THE REMNANT AT GREENWOOD II

SITE PLAN

THE REMNANT AT GREENWOOD II RAD
MCKINNEY HOUSING AUTHORITY
1001 A THROCKMORTON ST
MCKINNEY, TX 75069
PERMIT PACKAGE

DRAWN BY:
CHECKED BY:
SHEET TITLE
FENCE DETAILS
SHEET NO

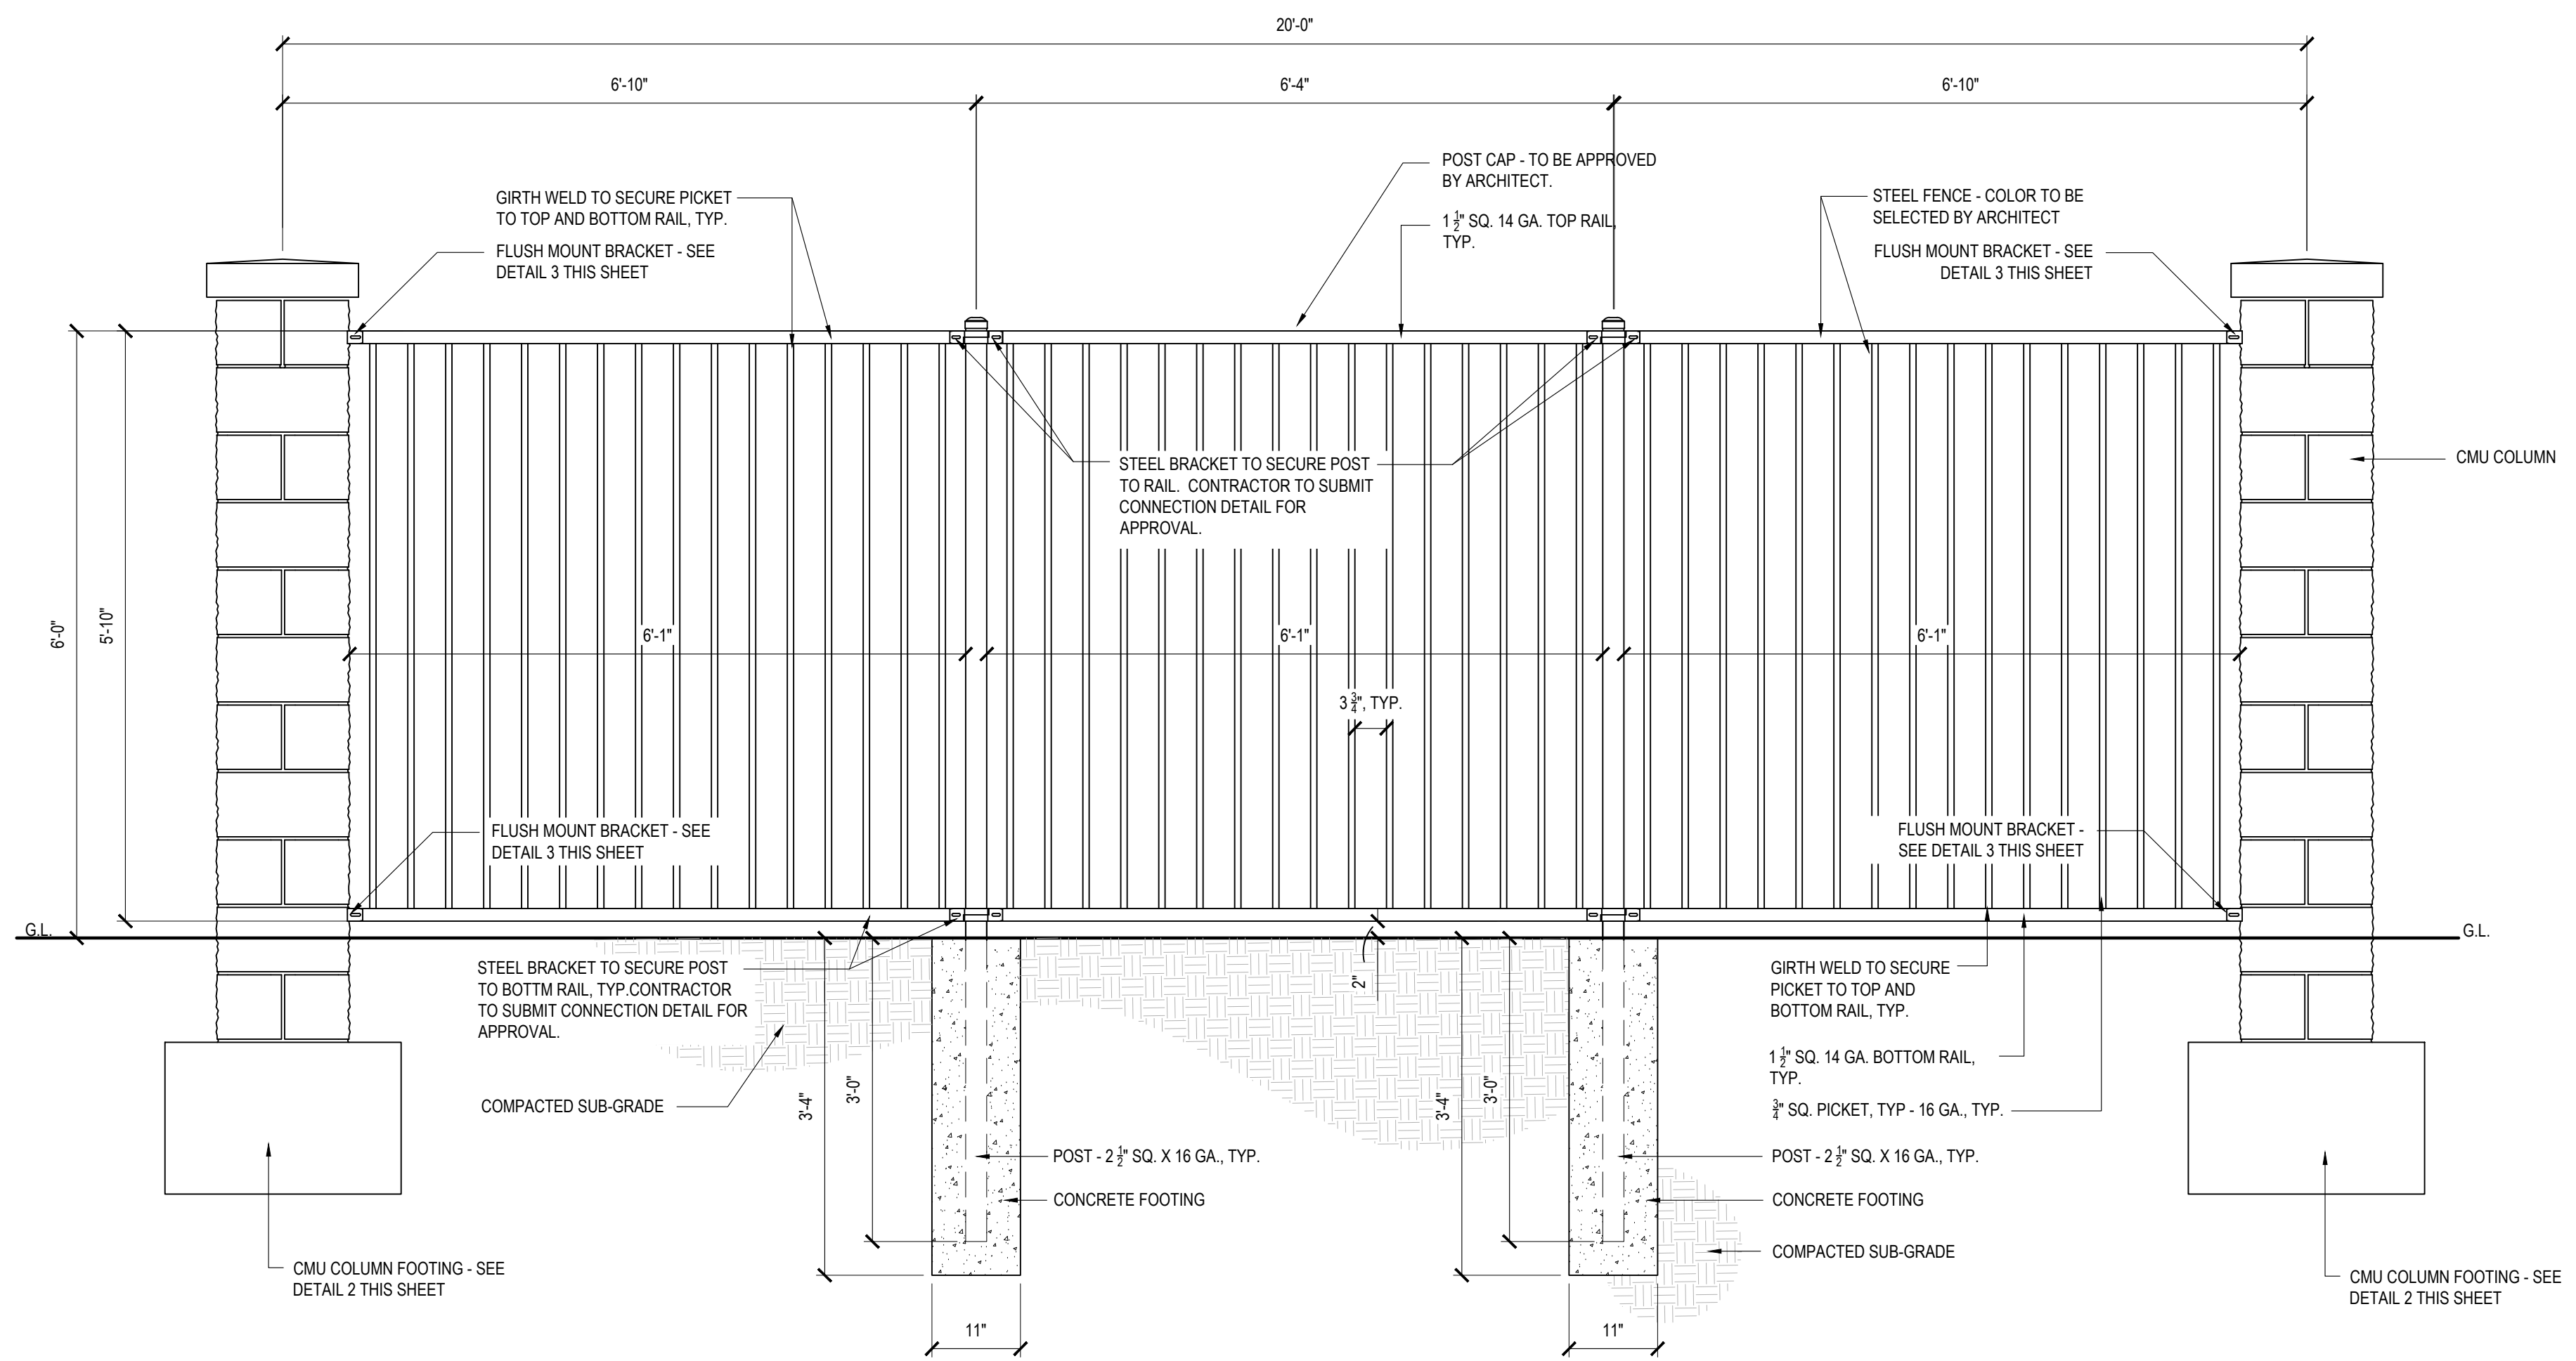
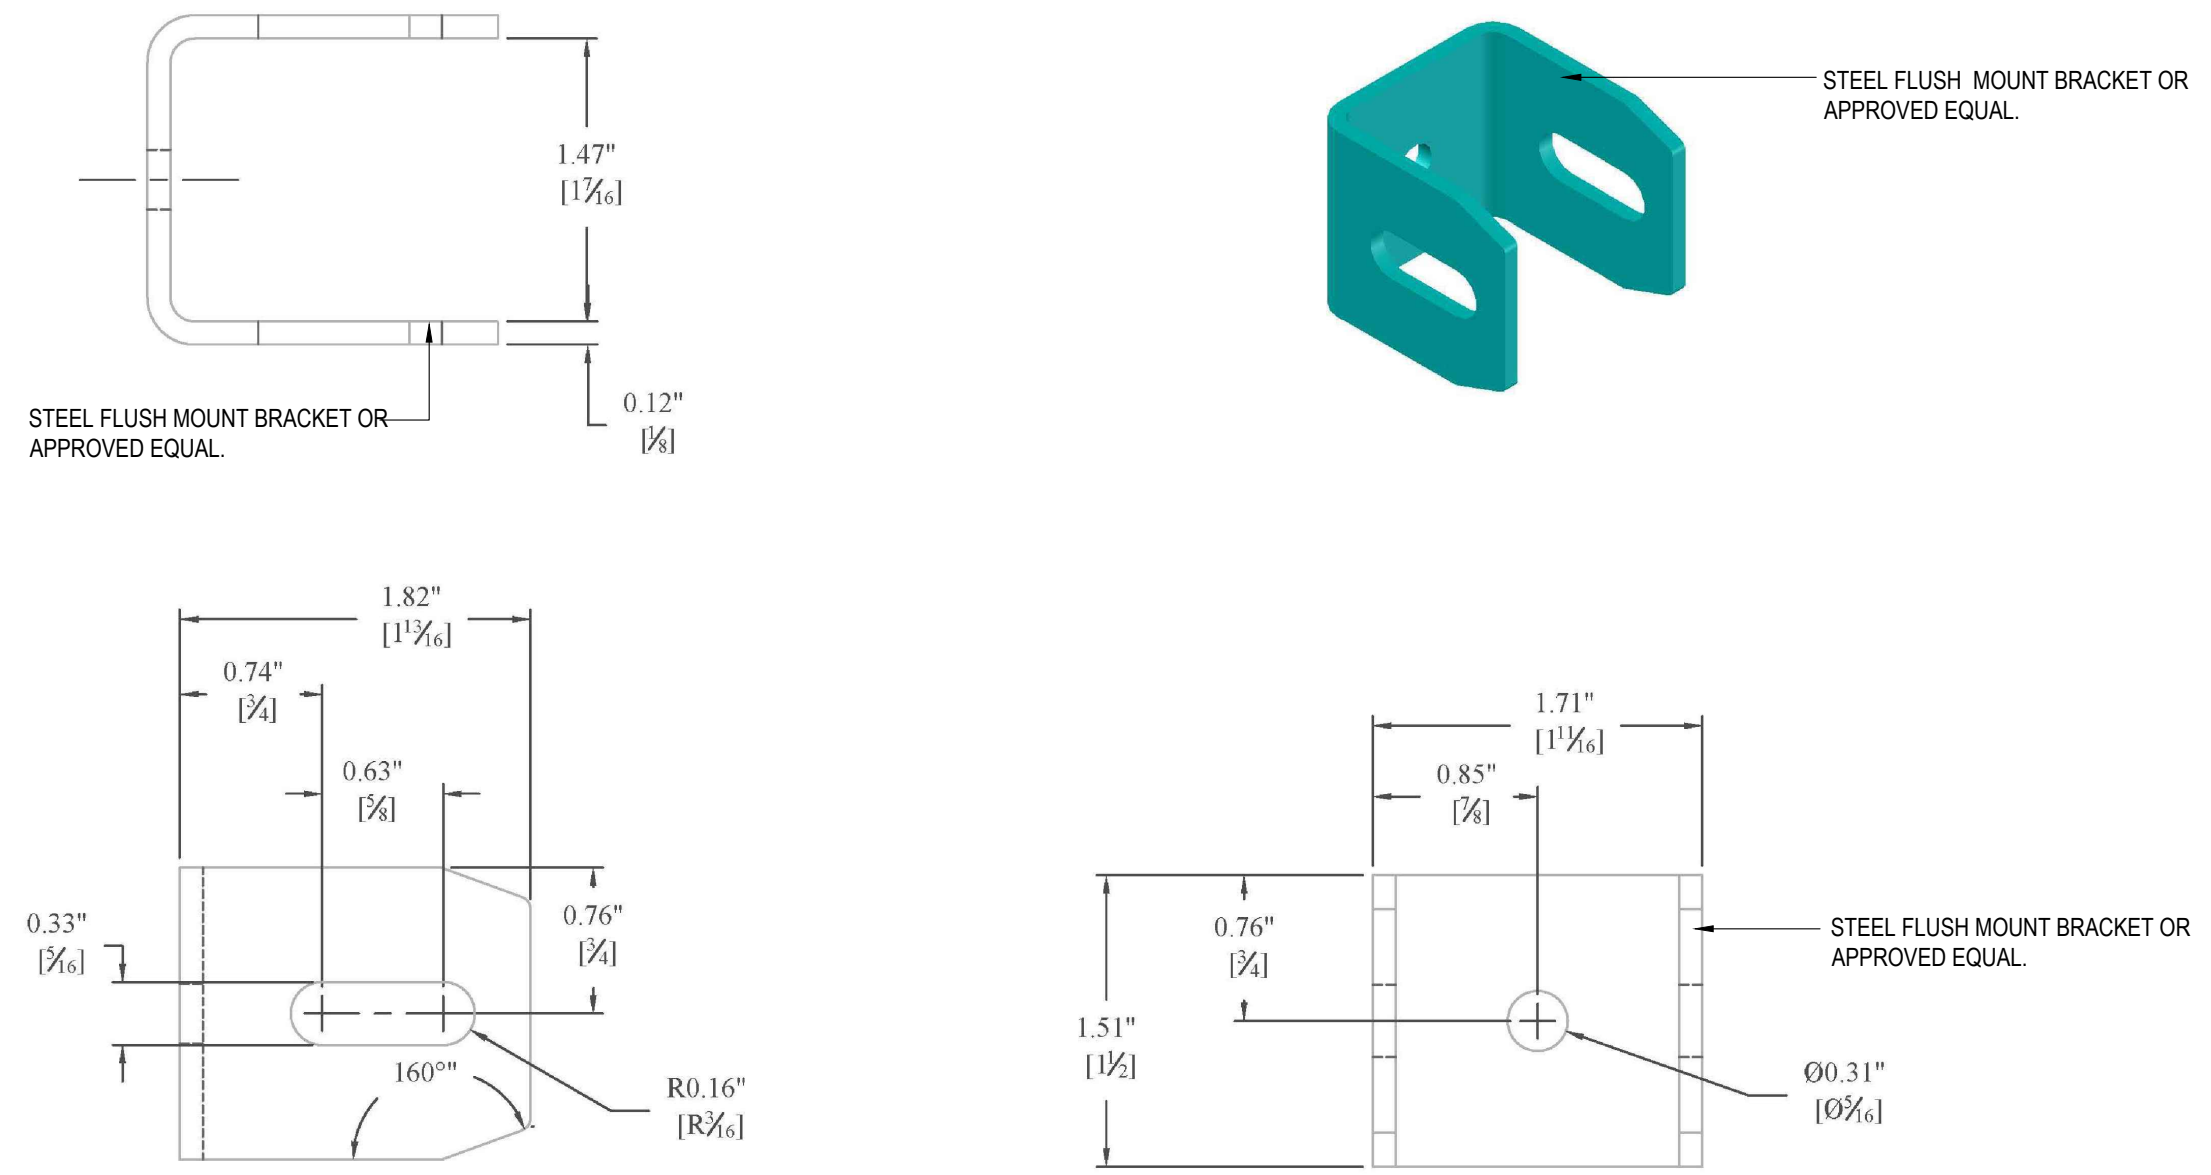
FENCE REMOVED FROM THE PROJECT SINCE NEIGHBOR HAS ALREADY BUILT ONE, APPROVED BY PLANNING DEPARTMENT ALREADY.
